Y. B. ESTATES (REPLAT)

SUMMARY

PROPOSED PLAT

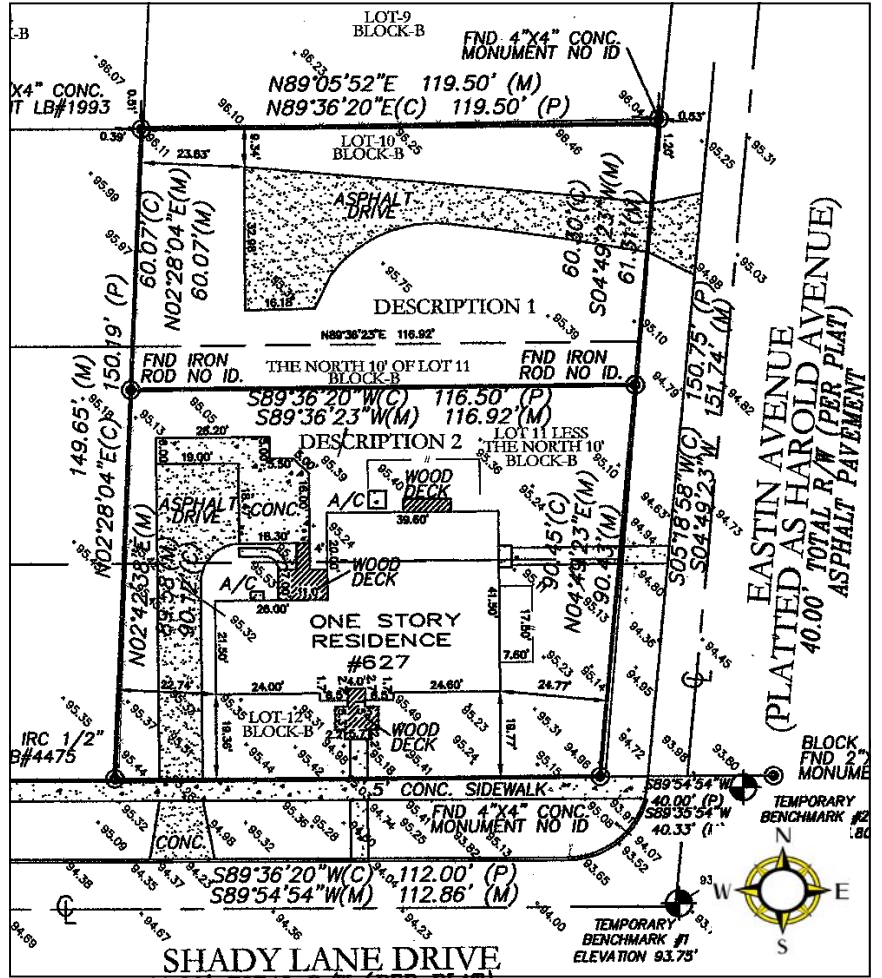
1. Plat Face Changes: In addition to the changes required on the plat, the following is a list of additional requirements:
 - a) Changes to the face of the plat (a copy has already been returned to the surveyor).

2. Stormwater/Flood Zone - The Public Works Department requires applicants to submit plans and surveys showing the current version of the FEMA flood zone map with the panel date shown within the zone boundaries. The map panels for the City of Orlando were updated in 2013, and additional updates may be available. For questions or assistance, call Lihua Wei, P.E. at 407.246.3897.
